DFM / DFA Analysis

Rear subframe bracket — «hostile» “fixture” × ½ (revision diff)

CHASSIS · ALUMINIUM A356 (CAST) · DIE CASTING (ALUMINIUM)

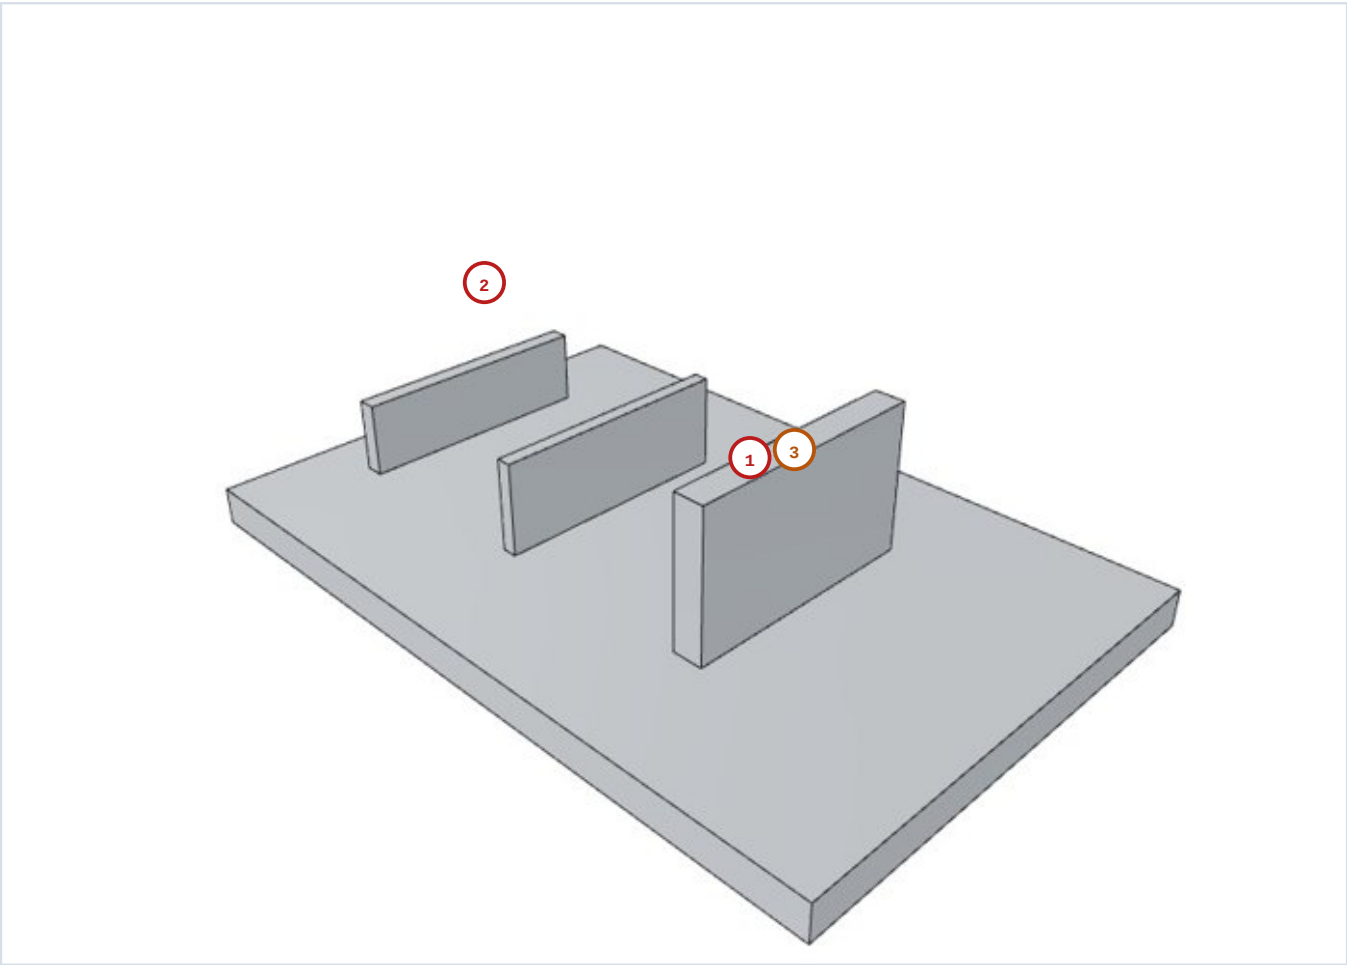
WHAT IS MARKED	MEASURED AGAINST ITS LIMIT	WHICH INSTANCE
1 Wall area below the minimum die-casting draft	41.2 % of wall area · limit <= 5	flattest of 2 under-drafted walls
2 Undercuts require slides or lifters in the die	3 regions · limit <= 0	largest of 3 undercut regions
3 Cored hole beyond the core-pin slenderness limit	14.2 core L/D · limit <= 10	worst of 9

Add at least 1.5 deg of draft to every wall parallel to the draw. Inside walls need roughly twice the outside figure because the casting shrinks onto them.

Shorten the cored hole to 10 diameters or open it up. A drilled secondary operation is the alternative and it carries its own cost.

Redesign the three occluded faces so they release along the draw, or budget a slide for each. A lifter is cheaper than a slide where the feature is shallow.

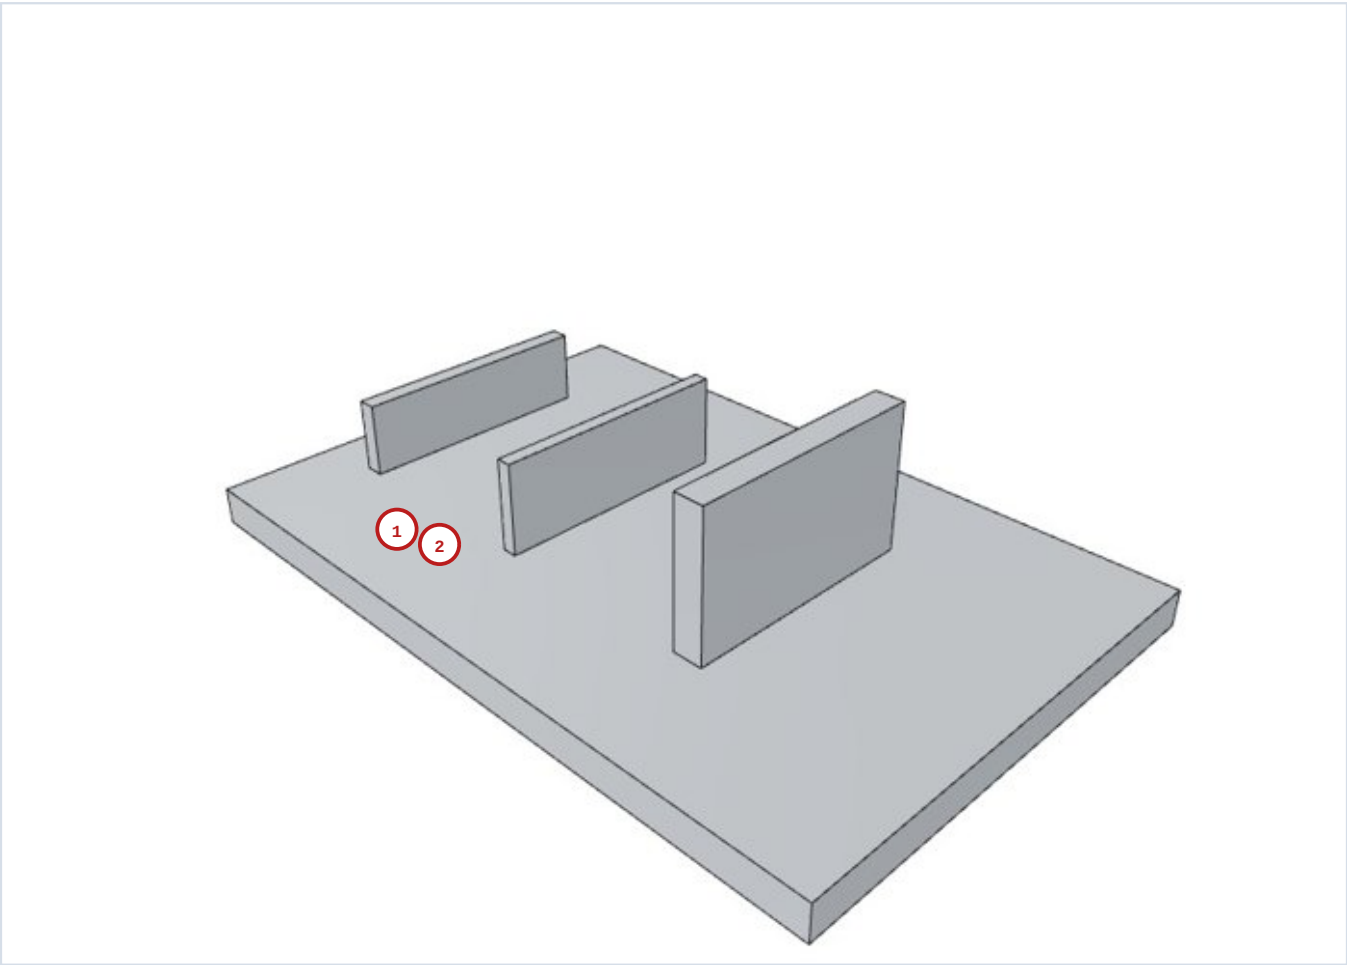
WHAT IS MARKED	MEASURED AGAINST ITS LIMIT	WHICH INSTANCE
1 Wall area below the minimum die-casting draft	41.2 % of wall area · limit <= 5	flattest of 2 under-drafted walls
2 Undercuts require slides or lifters in the die	3 regions · limit <= 0	largest of 3 undercut regions
